## HILTON TRU HOTEL JSP 17-54

Consideration at the request of Great Lakes Hospitality Group for Planning Commission's approval of Preliminary Site Plan and Storm Water Management Plan. The subject property is approximately 3.58 acres and is located south side of Thirteen Mile Road and east of M-5 in section 12. The applicant is proposing to construct a four story 98 room hotel. The site layout proposes associated parking, loading and bike facilities. Site access is provided off of Thirteen Mile Road.

# PLAN REVIEW CENTER REPORT

## Planning Review

**SITE PLAN**

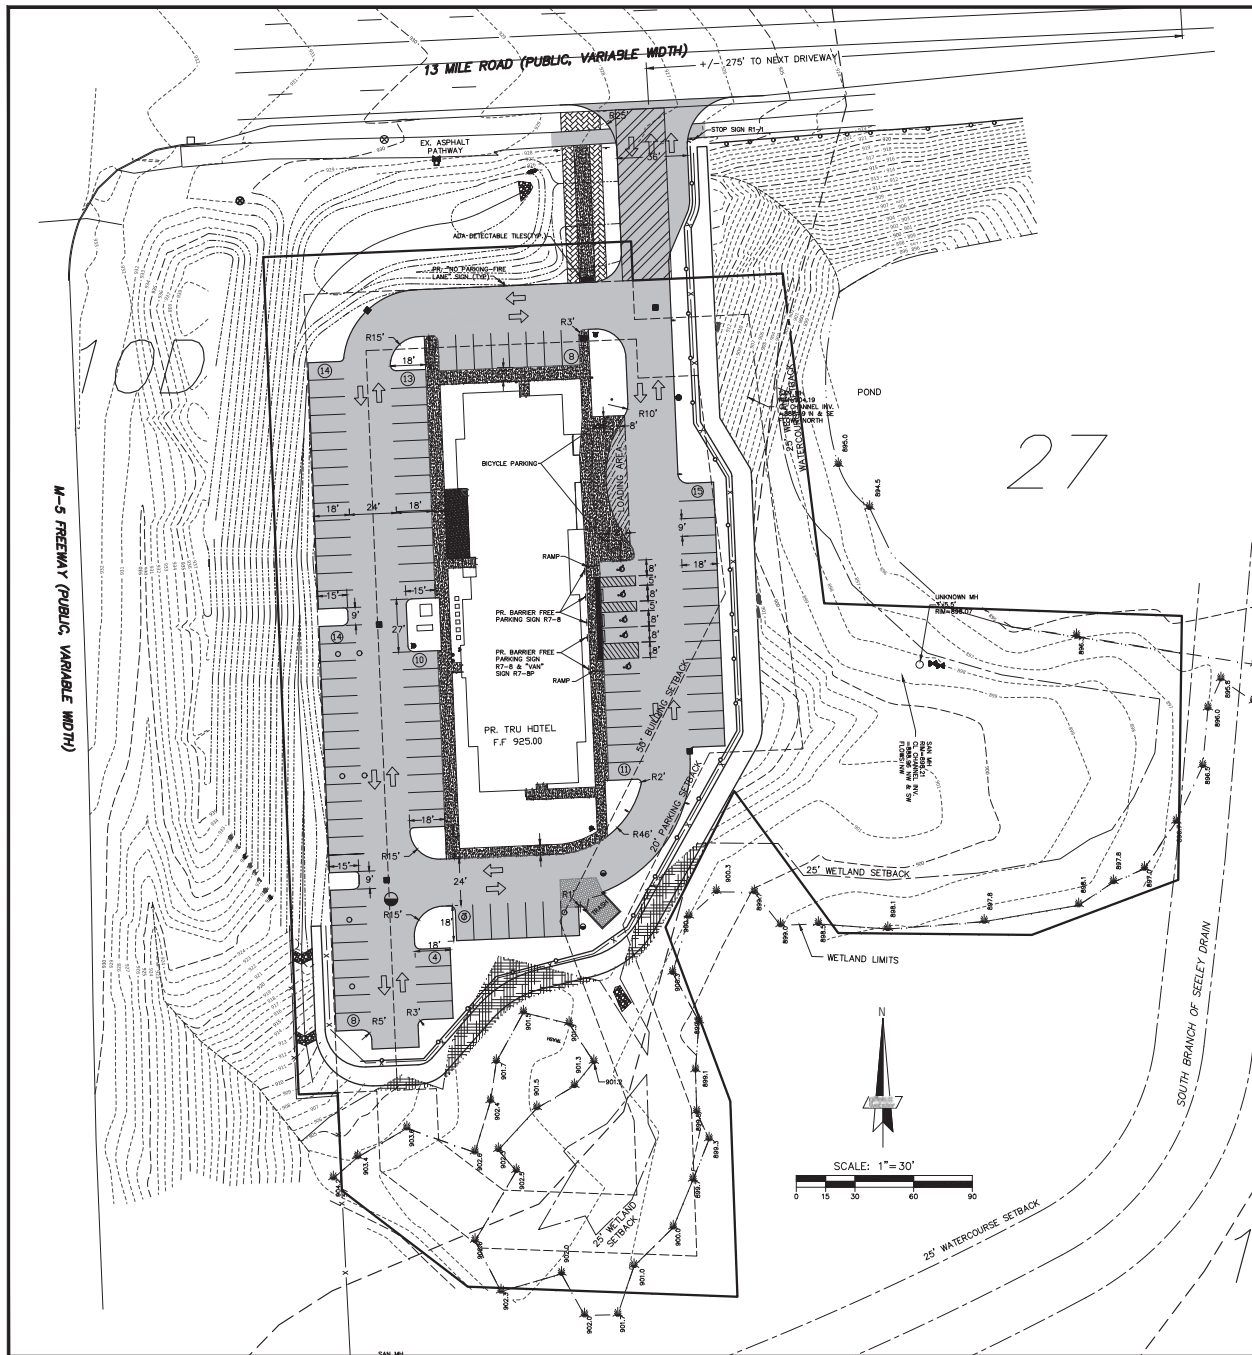
- **What is the largest vehicle that will be using the loading zone?**
3. Pedestrian Connection: **Proposed sidewalk connection from site to public sidewalk is primarily a secondary emergency access. The access requires an emergency gate at the site entrance. This would obstruct the continuity of the sidewalk. Wrap the sidewalk around the gate to provide continuous access.**

**DIMENSIONAL SITE PLAN**

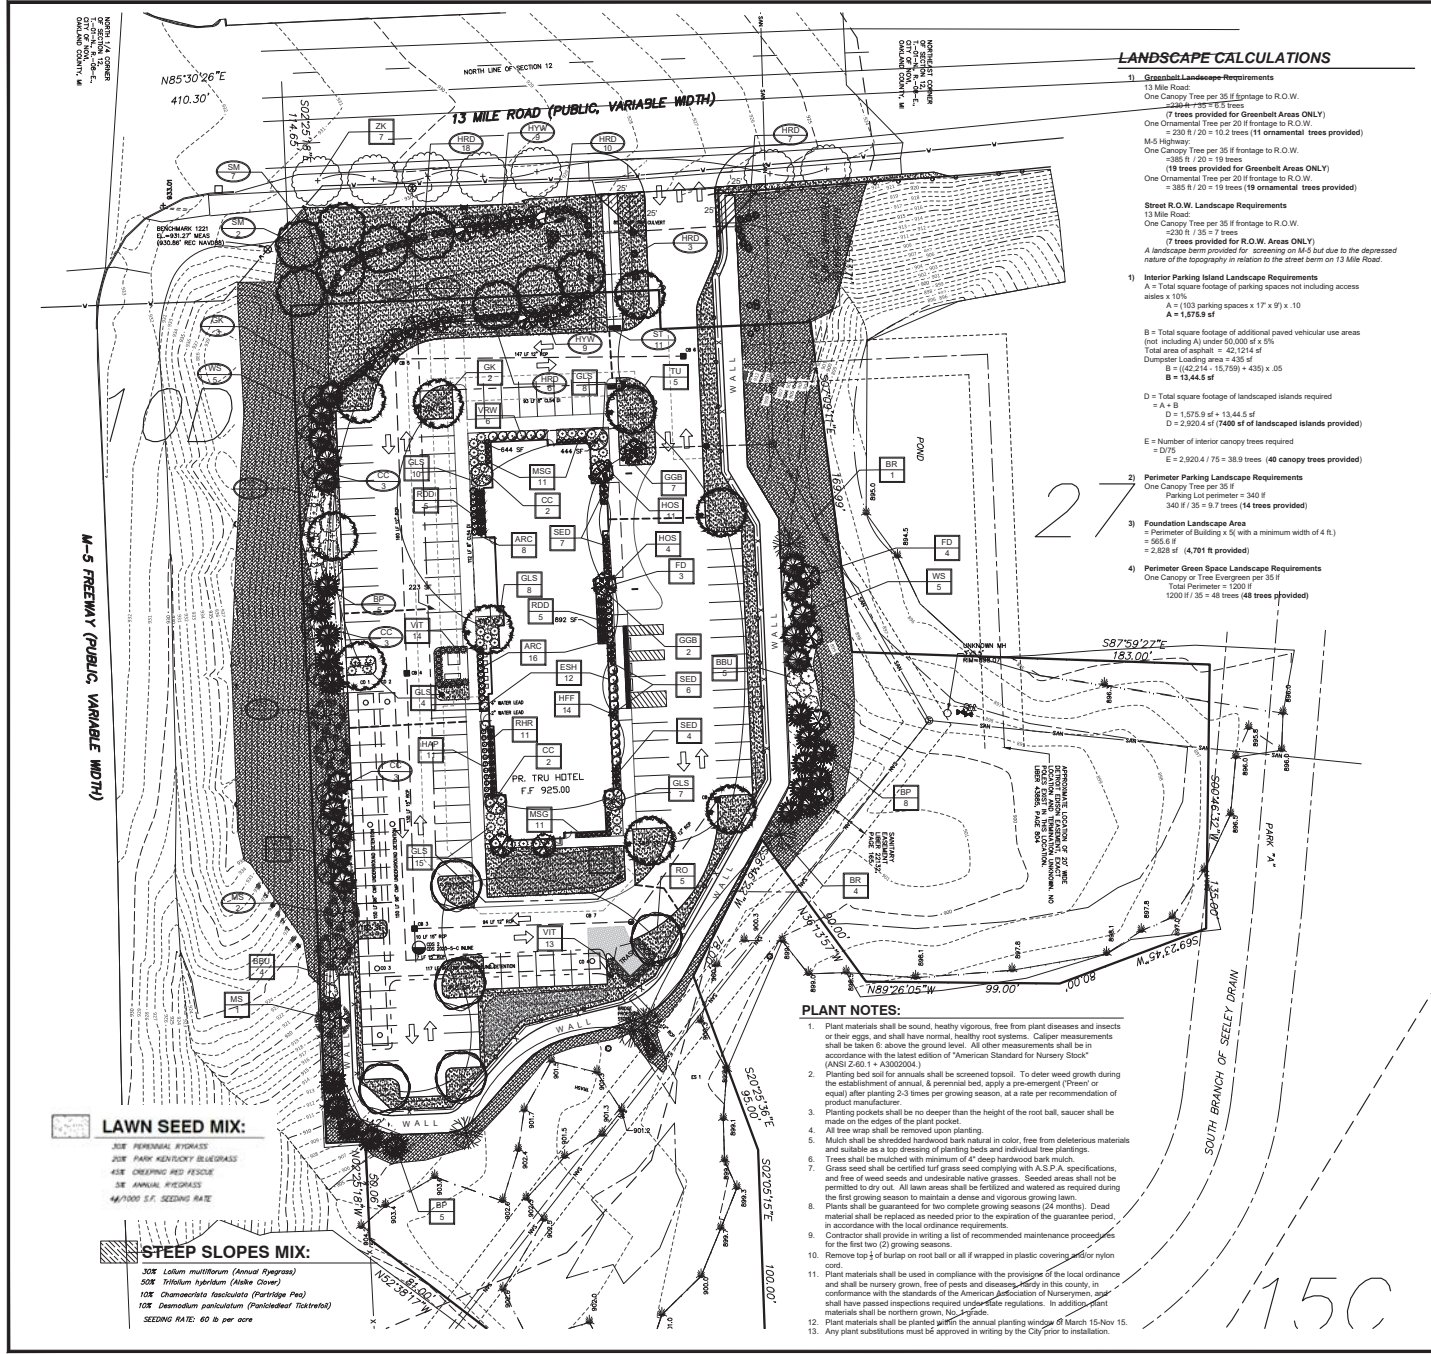
It should be noted that in addition to wetlands, the City of Novi also regulates the 25-foot wetland setback (i.e., buffer). The surveyed wetland boundaries as well as the 25-foot wetland setbacks are indicated on the Plan (including on the *Dimensional Site Plan*, Sheet 03).

Impacts to the 25-foot wetland setbacks are however proposed. The Plan (Sheet 03, *Dimensional Site Plan*) indicates two (2) areas of impact to the 25-foot wetland setback in the southern section of the site. These impacts are for the construction of a proposed retaining wall and entrance drive along the perimeter of the eastern and southern section of the site. The Plan indicates a total of 2,103 square feet (0.048-acre) of wetland buffer impact. The City of Novi's Zoning Ordinance (wetland/watercourse setback requirement) states:

- d. Curb details as well as a note on Sheet 03 indicate four inch curb and gutter throughout the site which contradicts the site grading and paving plan on sheet 04. Update the plan sheets to be consistent.
